Lloyd's Register of Shipping.

GLASGOW REPORT No 50695

the undersigned Surveyor to this Society did at the request of the Shipbuilders, Messrs. The Blythswood Shipbuilding Co. Ltd., survey the Steel Screw Motor Vessel "LAUREL", 10014 tons Gross of Stockholm as she lay in Govan Drydock, Glasgow, on the 7th July 1930 and the 28th July 1930 to ascertain the nature and extent of the Damages: "A" stated to have been caused by vessel striking quay wall at entrance to Princes Dock on 7th June 1930 and "B" stated to have been caused by vessel again striking quay wall at Princes Dock during undocking on the 11th July, 1930.

"A" Damage.

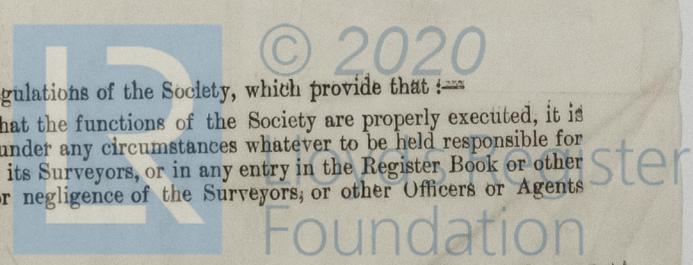
<u>FOUND.</u>	<u>RECOMMENDED.</u>
Shell plate No. 19 - E. Strake port side set in.	No. 19 plate E. Strake to be renewed.
Shell plate No. 19 - F Strake port side set in.	No. 19 F. strake to be renewed.
Longitudinal on F. 19 set in.	Longitudinal to be removed, faired and replaced.
